# Northview

Northview Residents' Association's response to planning application no P092219

## Why we are objecting to proposal no P092219

Detail of windows, showing frames and curves in the white rendering

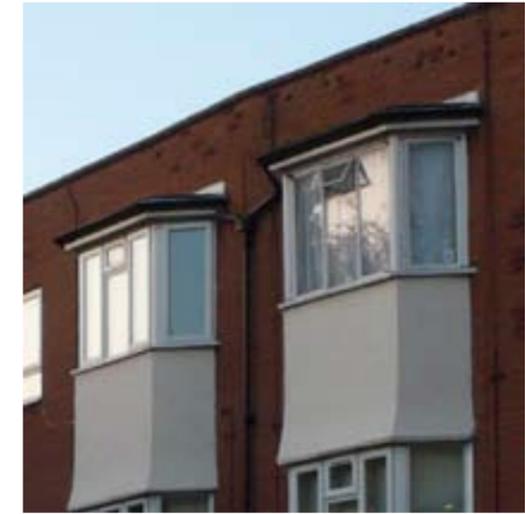
Sections of white rendering with columns of windows between them create visual columns to give the block height. The proposed drawing W09 shows the render around the windows rather than between them. The rendering between the windows appears heavy and straight in the drawings. Curved detailing on the rendering (see photo, above right) has been omitted from the drawings.
